1959 Corvette: Service Bulletin: Excessive Driveline Vibration

Source: General Motors of Canada Service Bulletin

Date: September 30, 1959

The propeller shaft and pinion angle and the elongation of the radius rod mounting bracket hole is shown in Fig. 44.

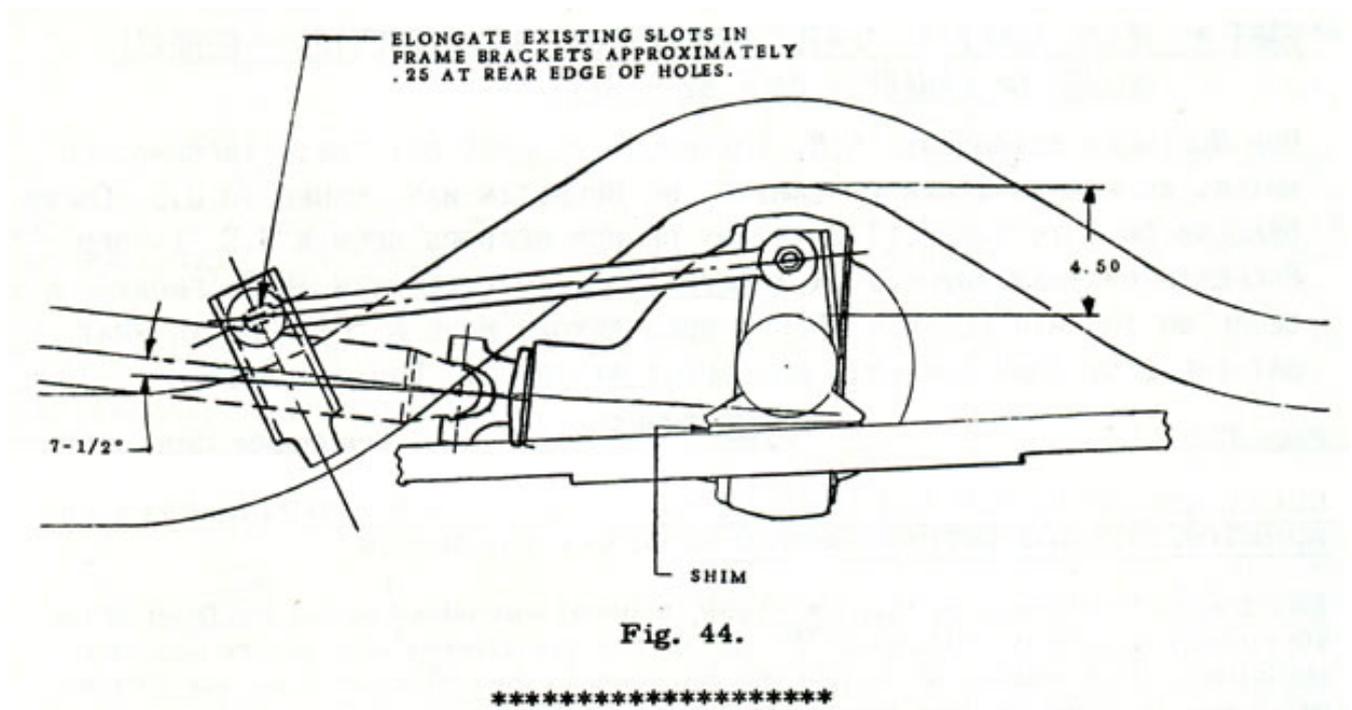
If excessive drive line vibration is encountered on the 1959 Corvette, it is probably due to excessive rear U-joint angle. Elimination of the vibration can be accomplished by installing either a 2° or 3° shim between the axle pads and springs on both sides, with the thick side to the front.

The nominal angle of the rear U-joint is 7-1/2°. Care should be taken in not going under 7-1/2° due to interference at full bump position.

2. The radius control rods should be disconnected before installing the shim. Before re-attaching the radius control rods, elongate the radius rod frame mounting hole 1/4" rearward if necessary to eliminate any interference between the radius control rods attaching bolt and mounting bracket. Shim part #3722797 (2 °), or #3744488 (3 °), or their equivalent may be utilized. The locating tab on the above shims should be removed to allow the shim to lie flat.
